Oconee Nuclear Station Regulatory Conference

Atlanta, GA
February 6, 2006

Summary of NRC Significance Determination Process Issue

NRC Risk Issue #3 (cont.)

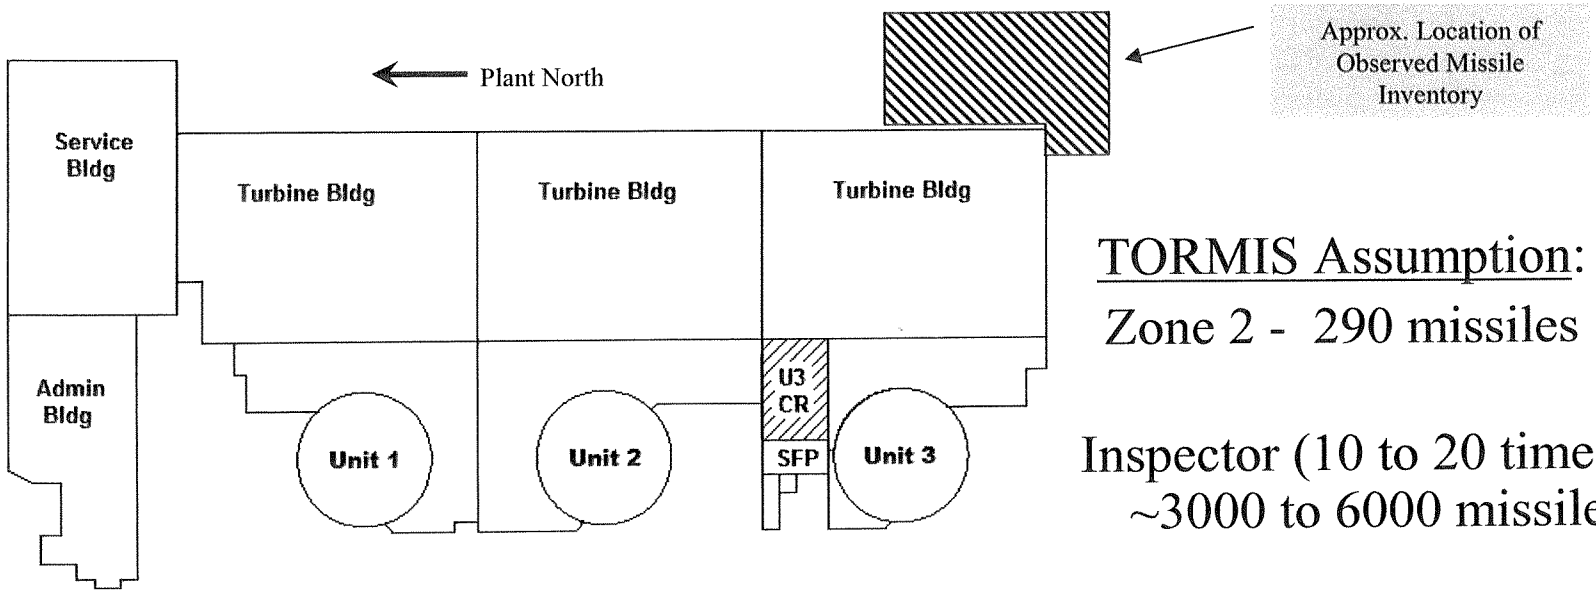
- NRC: Inspectors estimated actual missile count to be 10 to 20 times higher than assumed in the TORMIS model, and would increase the likelihood of missiles striking the wall.
- Duke Clarification:
  - Materials observed in November 2003 were located at southeast corner of Turbine Building (away from the Unit 3 control room north wall)
  - Materials observed were used to support outage activities and not present continuously through the year

Inspector (10 to 20 times) = ~3000 to 6000 missiles

- Missile inventory for the entire site did not increase by 10 – 20 times.

TORMIS Assumption:

Zone 2 - 290 missiles

TORMIS Assumption for Site (All Zones): 33,434 missiles

TORMIS Missile Zones

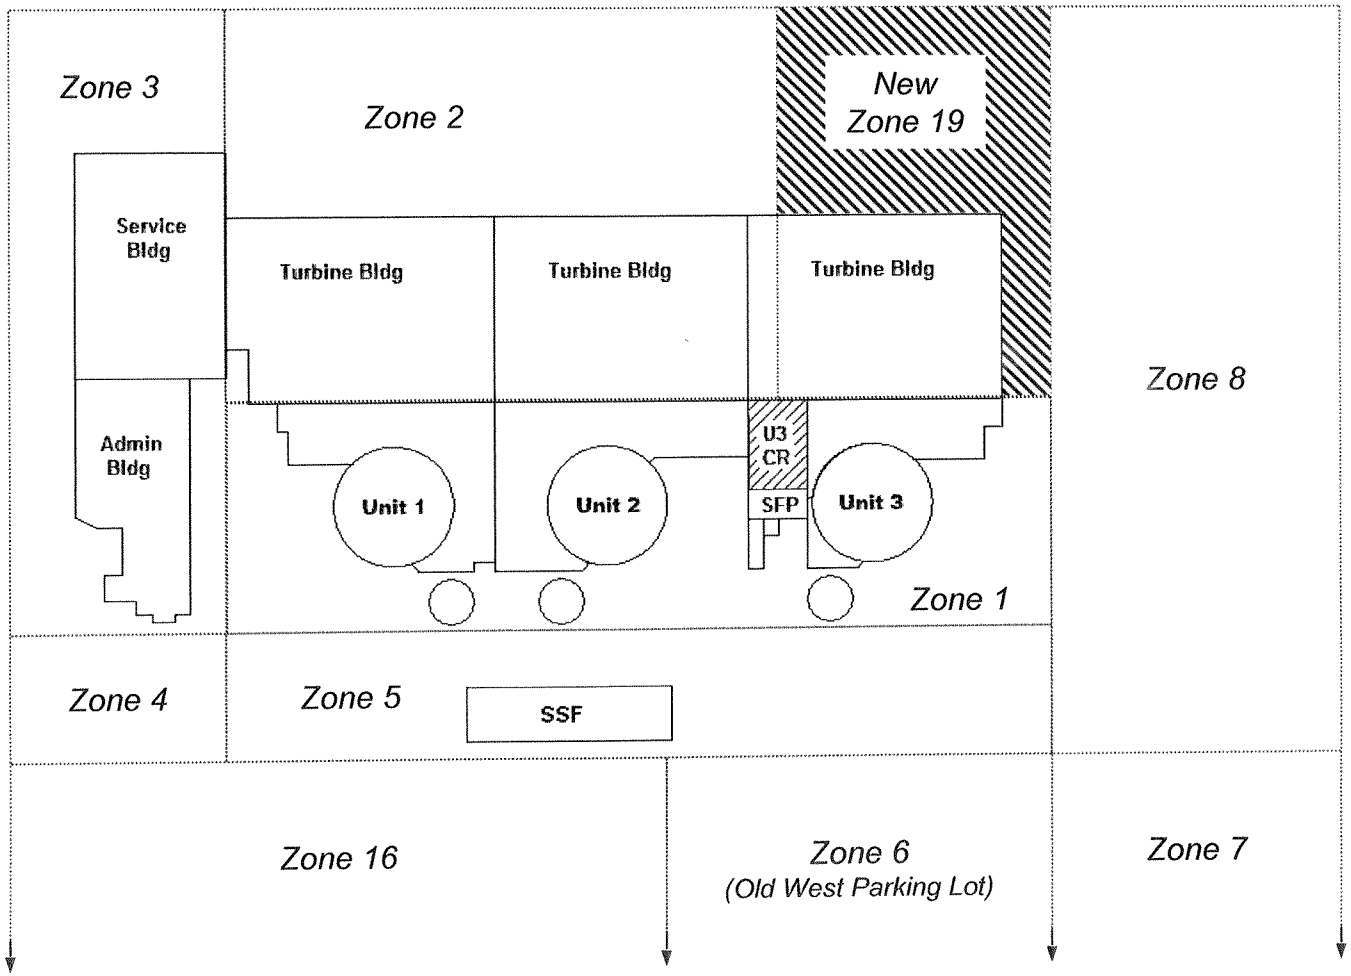
- TORMIS sensitivity case
  - Increased inventory observed by inspectors was modeled in new "Zone 19".
  - Sensitivity case intended to represent "bounding" case analysis.
    - Approximately 50 times base in same area (versus inspector's estimate of 10–20 times)
    - Other potential storage/staging areas were increased by similar amount (Zones 6 & 8).

Location	Base Case	Bounding Case	Change
Zone 6	1038	15,600	15 X
Zone 8	333	16,650	50 X
Zone 19	-	14,500	50 X Zone 2
All Zones	33,434	78,813	2.36 X
